GE Nuclear Energy

MFN 050-96
Docket No. 52-001

ABWR Design Change Assessment Review of FOAKE Design Changes

PROPOSED CHANGES

Figure 2.15.5a Control Room Habitability Area HVAC System

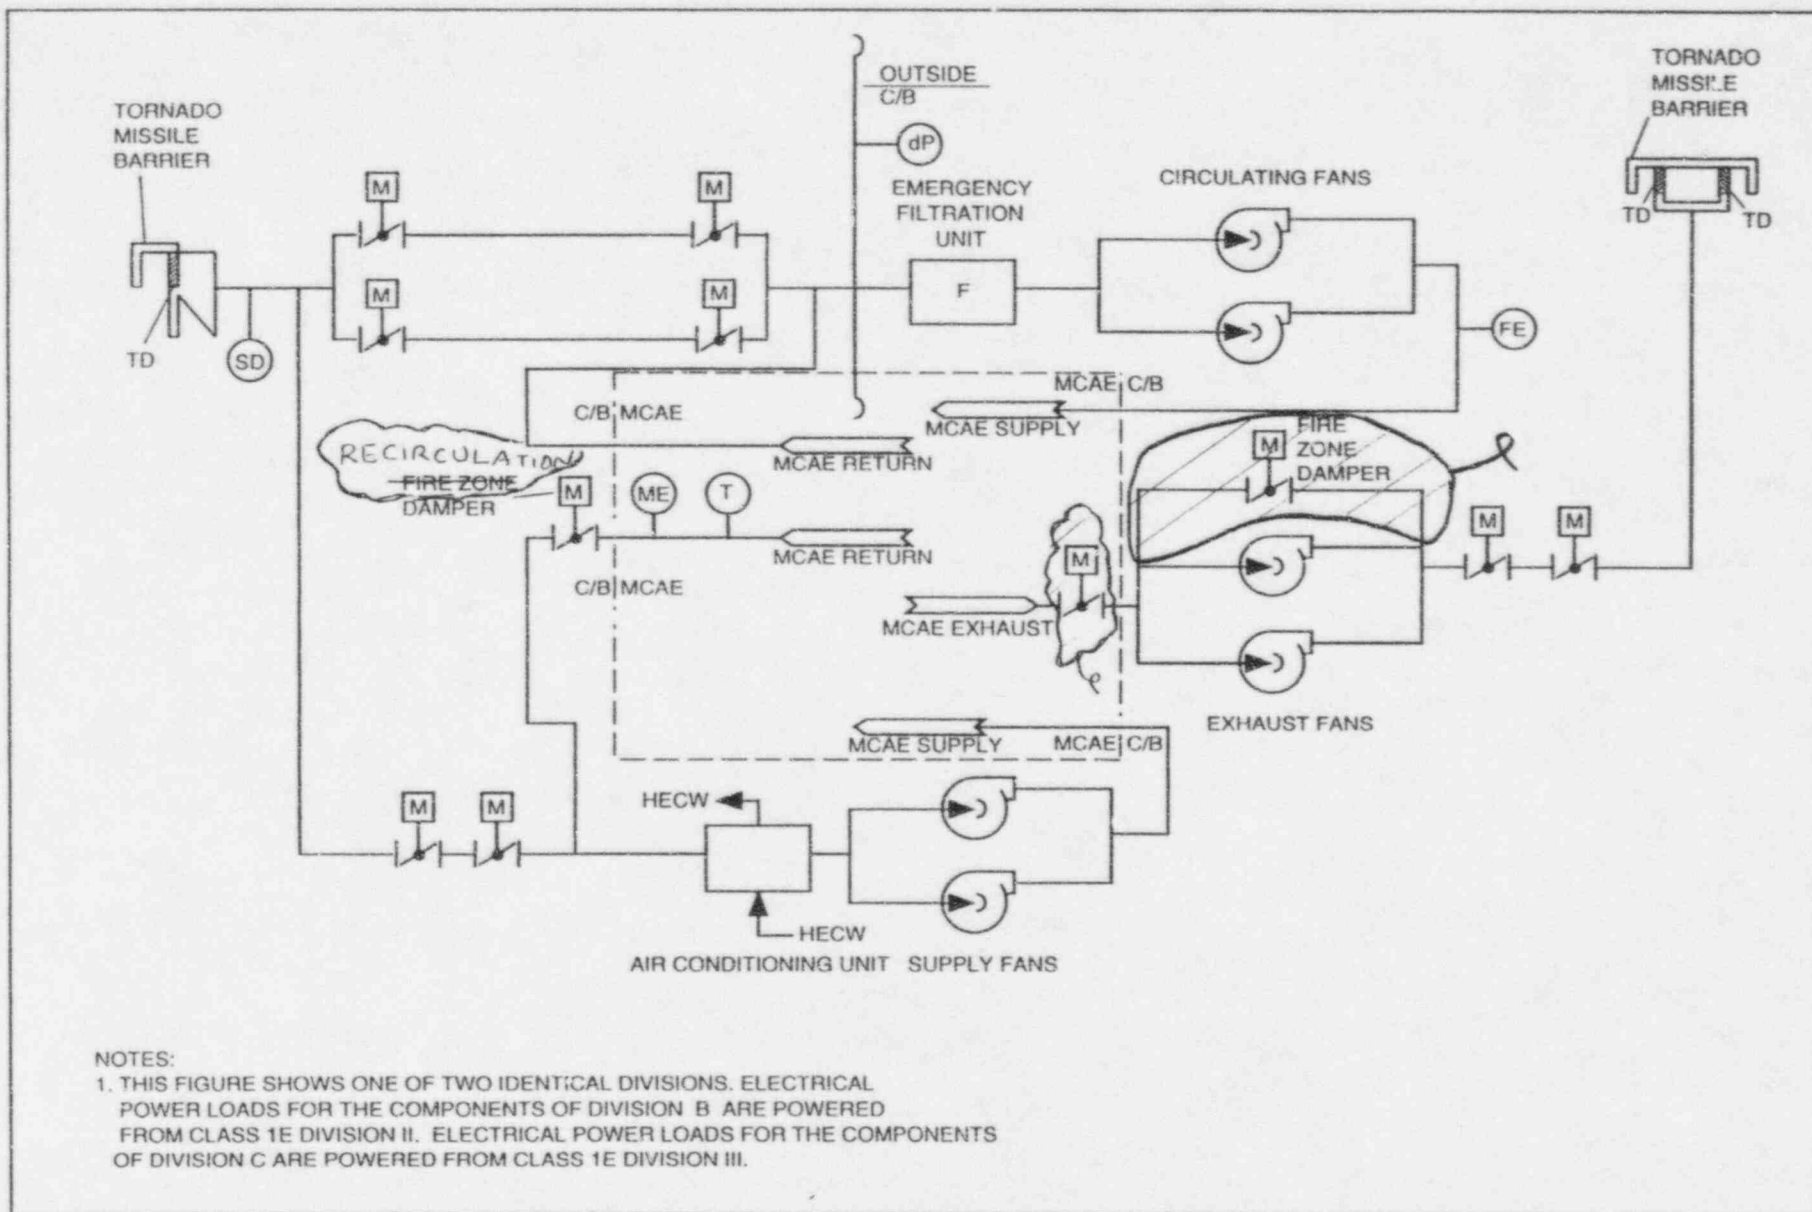
The smoke removal mode is manually initiated by closing the recirculation damper, ~~stopping the exhaust fan, and opening the exhaust fan bypass damper~~ to allow outside air purging of the affected Control Building area. The normal operating mode is used to remove smoke from the battery rooms.

Figure 2.15.5a Control Room Habitability Area HVAC System

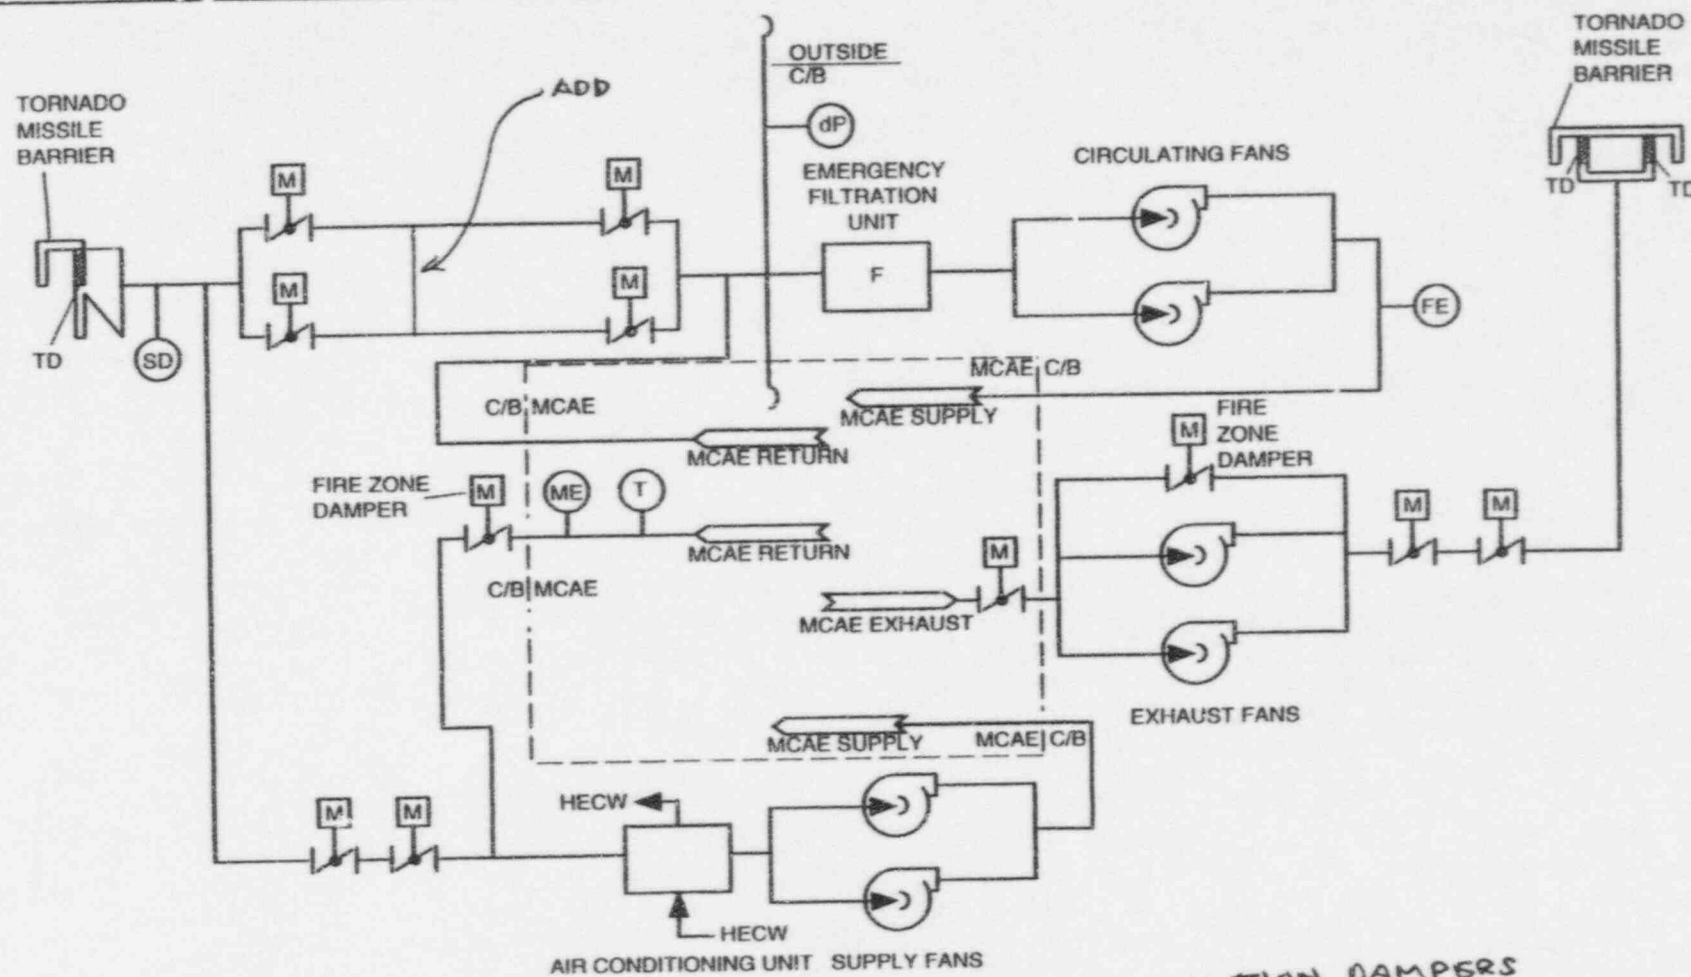
Each of the two CRHA HVAC System divisions, with the exception of the motor operated isolation dampers, is powered from the respective Class 1E division as shown on Figure 2.15.5a. Each pair of motor operated isolation dampers in series is powered from two independent Class 1E divisions (one damper is powered from Class 1E division II and the other damper is from Class 1E division III). In the CRHA HVAC System, independence is provided between Class 1E divisions, and also between the Class 1E divisions and non-Class 1E equipment.

2. EACH PAIR OF MOTOR OPERATED ISOLATION DAMPERS HAS ONE DAMPER POWERED FROM CLASS 1E DIVISION II AND THE OTHER DAMPER FROM CLASS 1E DIVISION III
